TO: HONORABLE CHAIRMAN AND PLANNING COMMISSION
FROM: WARREN FRACE, COMMUNITY DEVELOPMENT DIRECTOR
SUBJECT: PD 05-012 AMENDMENT (BRUSH & CLAYTON)

DATE: JULY 28, 2015

Needs: For the Planning Commission to consider applications filed by Kevin Brush and Frank Clayton, to amend PD 05-012 amending the development standards for Lots 1-48 of Tract 2594. (APNs: 025-371- 001 thru 048)

Exhibit A Architectural Site Plan Tract 2594 & PD 05-012 (Robert Shannon)

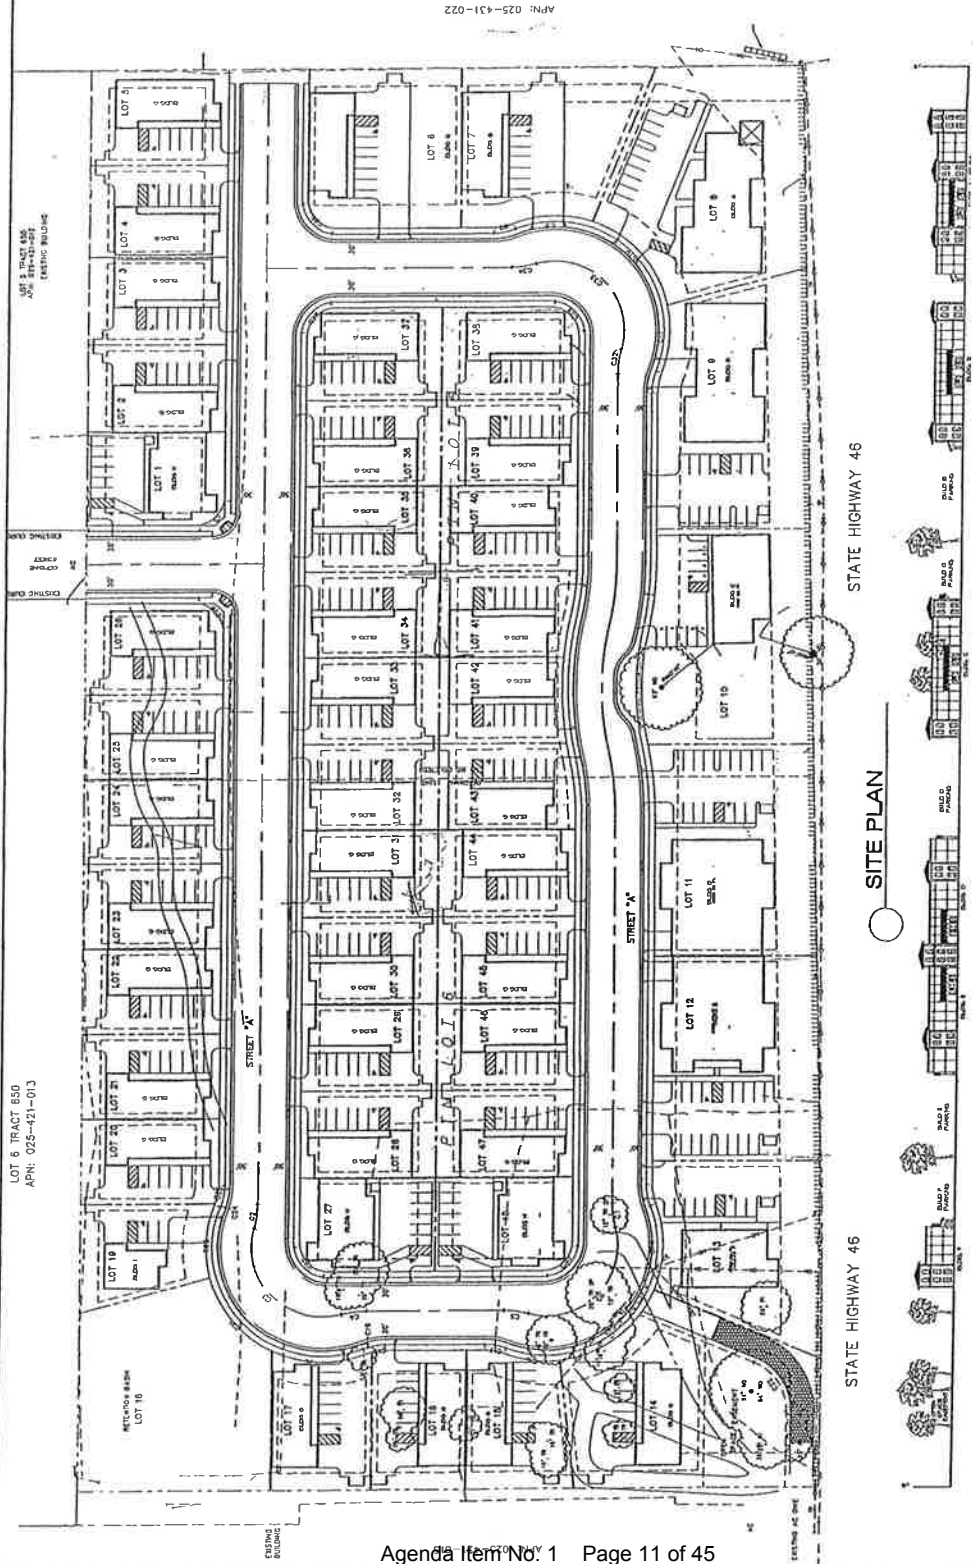
- No. 7: reduce the front and street side setbacks from 10-feet to 6-feet;
 - No. 8: allow building square footages less than those provided for on Exhibit A, Architectural Site Plan, and acknowledge the ability to have outdoor display on individual lots as long as the display is associated with an established building and as long as the use is permitted in the zoning district;

With the original subdivision, condition No. 8 was included to insure that Lots 8-12 have larger buildings since they were the larger lots along Highway 46 East. The concern was that if there were no parameters established that unsightly uses, such as general outdoor storage adjacent to the highway might be approved which would not result in an attractive entrance to the City. While it would seem that a vehicle sales business would be a good use for the lots along the highway and would be similar to other vehicles sales businesses in the area, the current PD requirements would require that the building be approximately 7,500 square feet. It would be necessary to amend Condition No. 8 to allow for buildings less than the square footages indicated on the original architectural site plan.

Regarding the Clayton request to amend Condition No. 8 allowing for a reduced building size on Lots 8-12, since new vehicle sales is a permitted use in the C3 zoning district, it would seem reasonable to allow such a use on the lots 8-12. Through the development review process and review at the DRC level, site planning, architecture, landscaping and fencing can be reviewed to insure that the project provides a good presentation along the Highway 46 frontage.

8. *The lot sizes and building square footages for the Lots 8-12 are intended to be larger to provide more massing along Highway 46 East, therefore future development of these lots shall substantially comply with Exhibit A, Architectural Site Plan, however, subject to the approval of a Site Plan review by the Development Review Committee, reduced building square footages can be approved, with a DRC finding that the project has been designed to provide aesthetic qualities for the building and site along the Highway 46 frontage. Signage along Highway 46 shall be limited to building wall mounted signs. If a free standing monument sign is proposed, it shall be no taller than 6-feet in height and 32 square feet in size. Please note that if a monument sign is utilized at the back of the lot for view from Highway 46, a second monument cannot be provided on the front of the site oriented toward Combine Street.*

Nick Gilman Letter

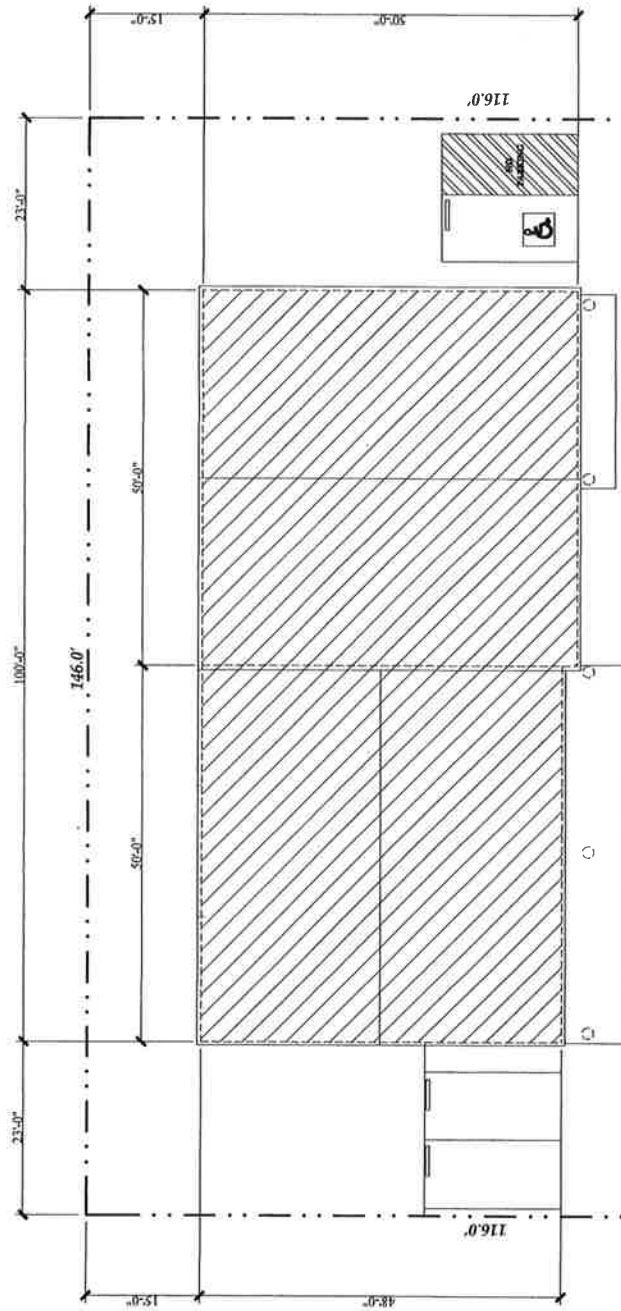
2. DELETE IN ITS ENTIRETY. A VARIETY OF ARCHITECTURAL PRODUCTS WILL ENHANCE THE FINAL RESULT AND ENCOURAGE POSSIBLE TENANTS. DRC REVIEW AND THE CITY'S ESTABLISHED GUIDELINES FOR METAL BUILDINGS WILL ACCOMPLISH ITEMS b, c, AND d, OF THE ORIGINAL FINDINGS.

4. "MASON SITE PLAN REVIEW" IS OVERKILL. DRC REVIEW SHOULD BE SUFFICIENT. (SEE CONDITION 15 ADDED.) THE REQUIRED SUBMITTALS Q.T.G. SHOULD REMAIN.

7. THE 10' SIDEYARD LANDSCAPE BELT (14' WITH THE 4' INSIDE OF SIDEWALK) SEVERELY DEPRECIATES THE CORNER LOTS. 5' OF LANDSCAPE INSIDE THE SIDEWALK SHOULD BE SUFFICIENT.

8. DELETE

9. DELETE

15. OWNERS OF ALL LOTS SHARING
A 30' WIDE DRIVEWAY SHALL
PREPARE A RECORDABLE JOINT ACCESS
EASEMENT IN FAVOR OF THE ADJOINING
PARCEL. SUCH EASEMENT SHALL BE
15' WIDE AND 45' LONG INTO THE PARCEL.
SUCH DOCUMENT SHALL BE IN A FORM
APPROVED BY THE CITY ENGINEER.

Exhibit A
Architectural Site Plan
Tract 2594 & PD 05-012
(Robert Shannon)

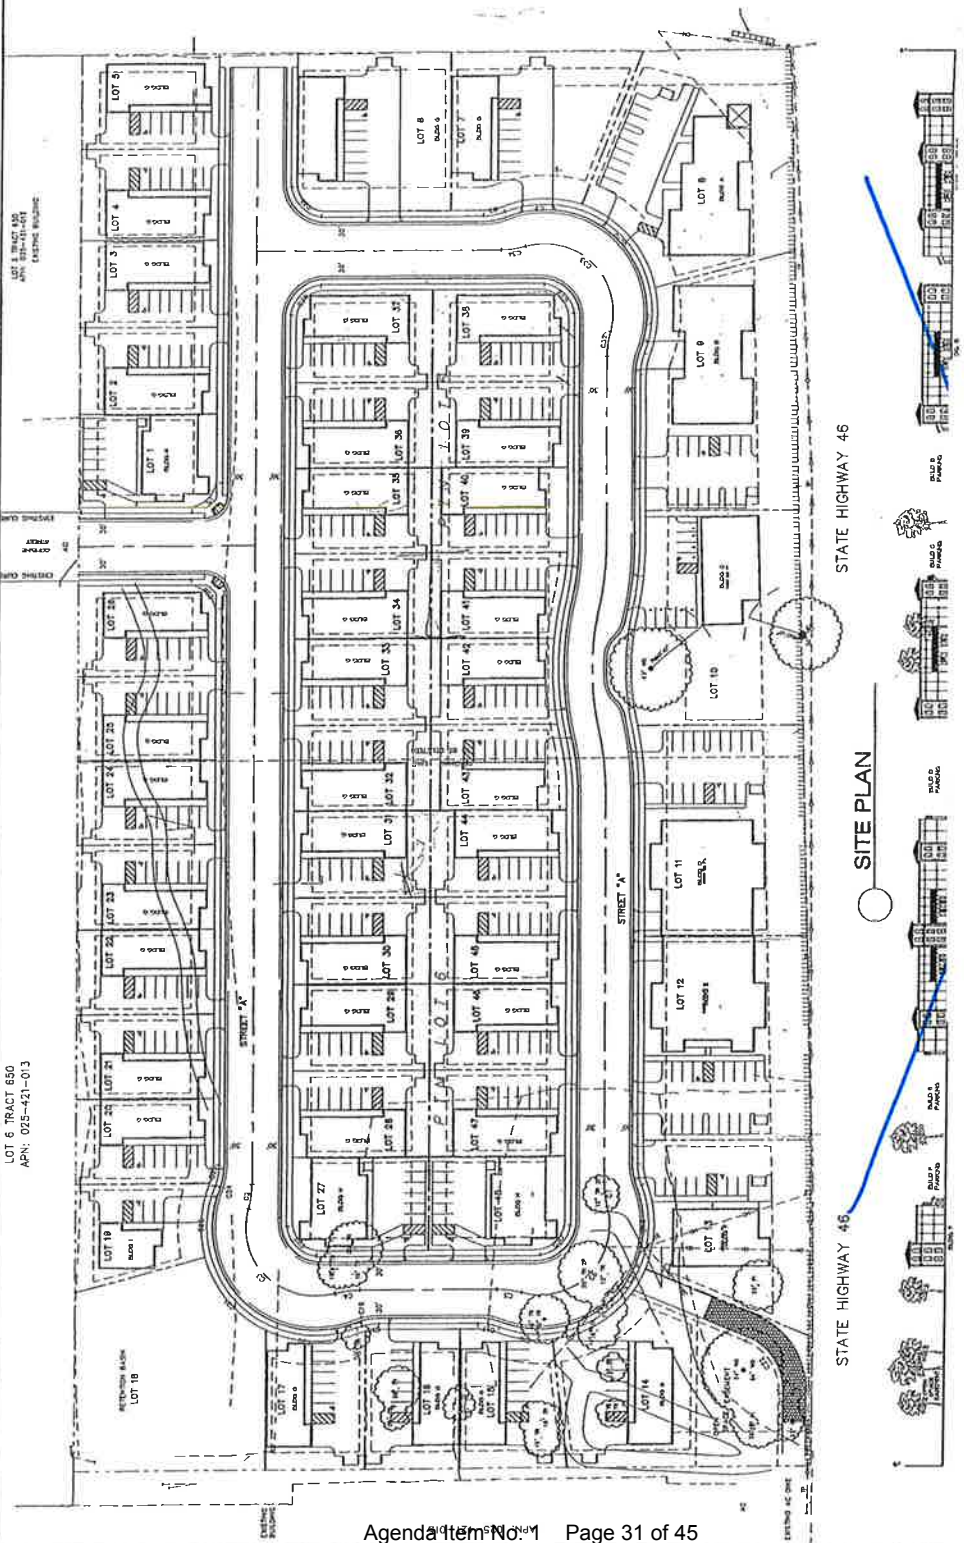
Exhibit F
See Industrial Guidelines, Exhibit F
for development standards.

Exhibit B1-B5
 Architectural Elevations
 Tract 2594 & PD 05-012
 (Robert Shannon)

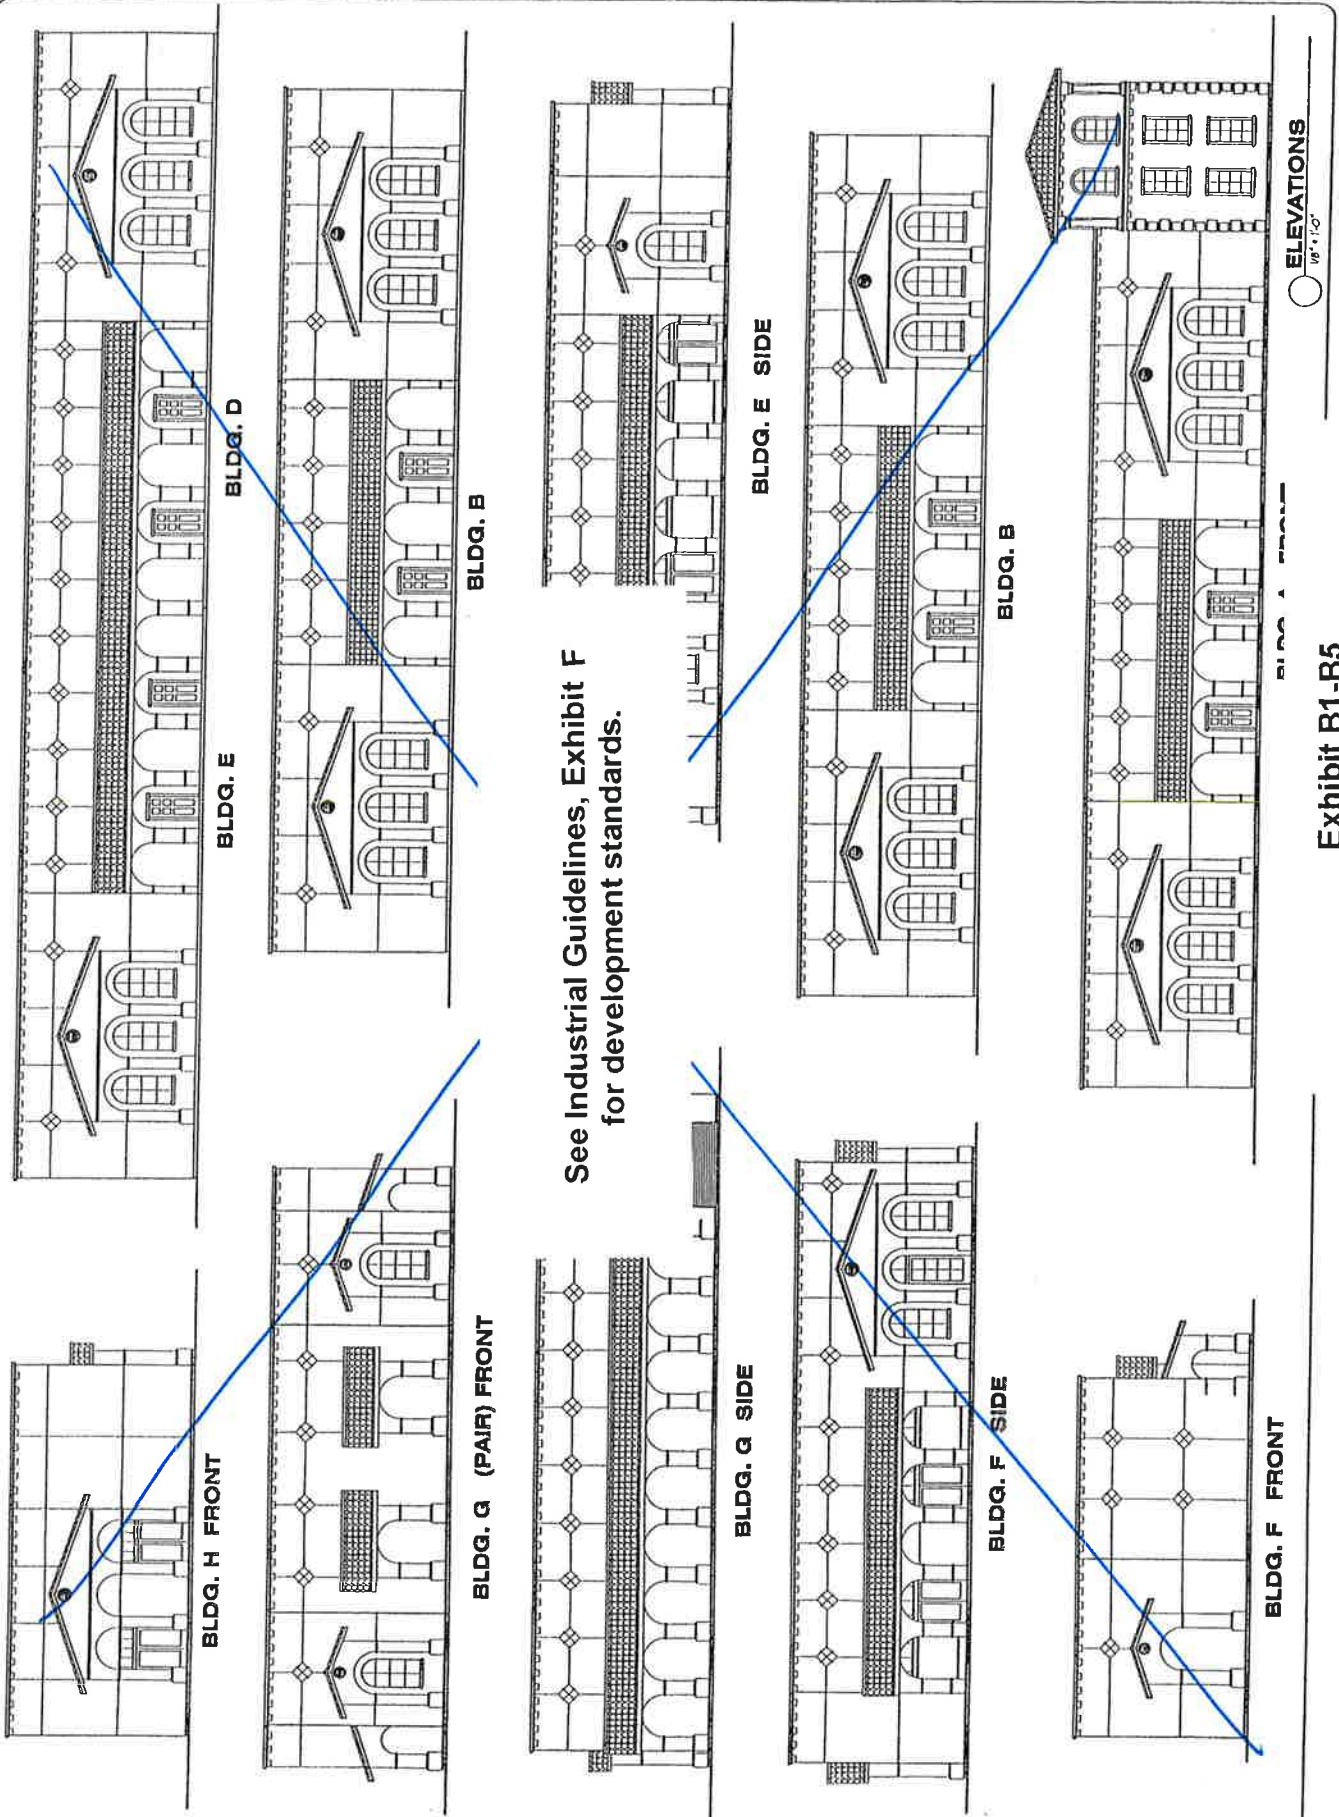
See Industrial Guidelines, Exhibit F
 for development standards.

Exhibit C1, C2
 Hwy 46 Landscape Plan
 Tract 2594 & PD 05-012
 (Robert Shannon)

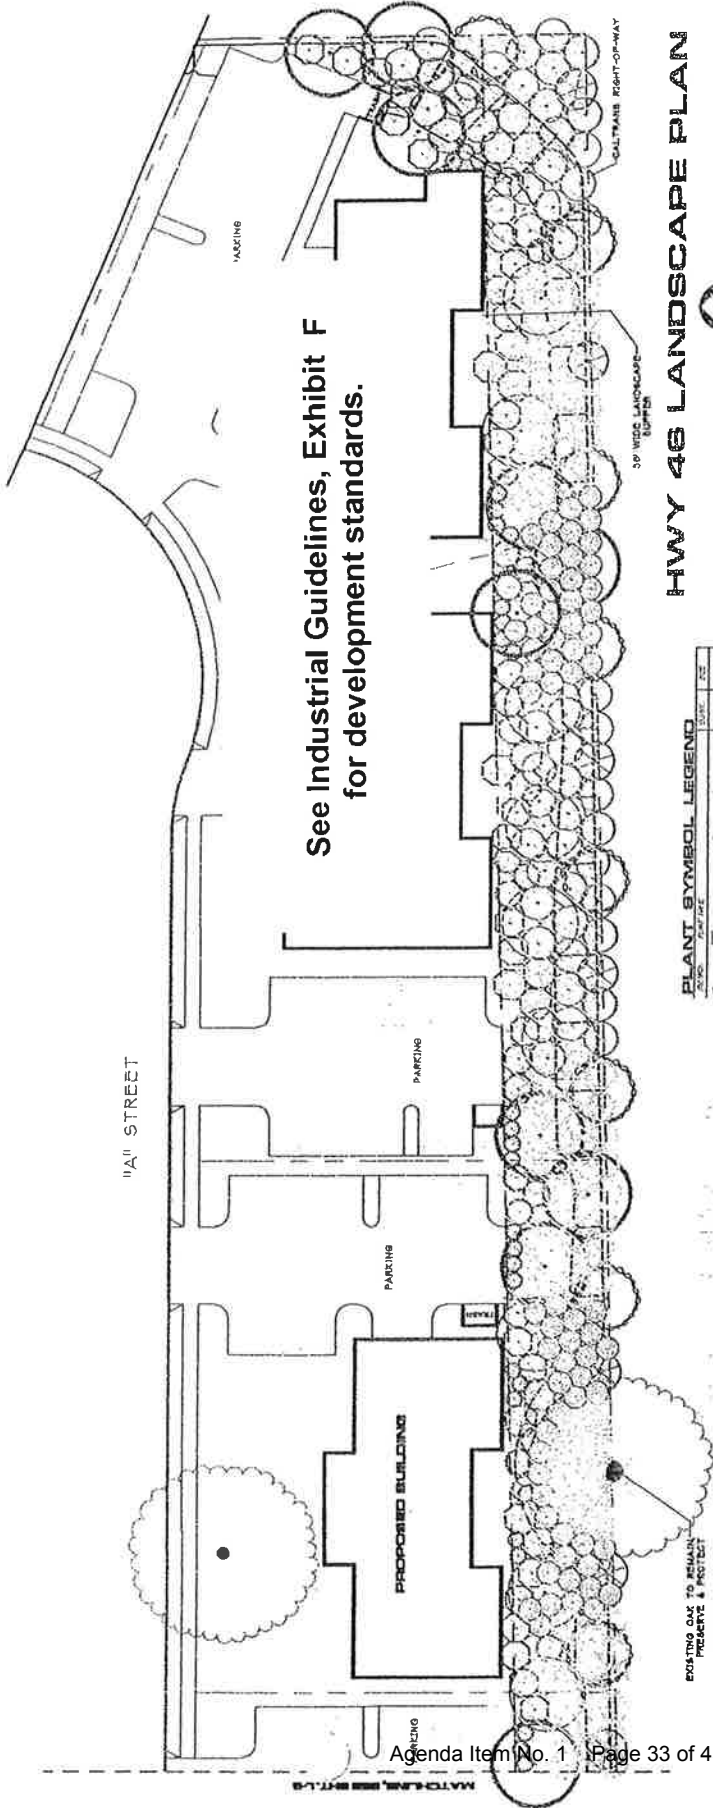
See Industrial Guidelines, Exhibit F
 for development standards.
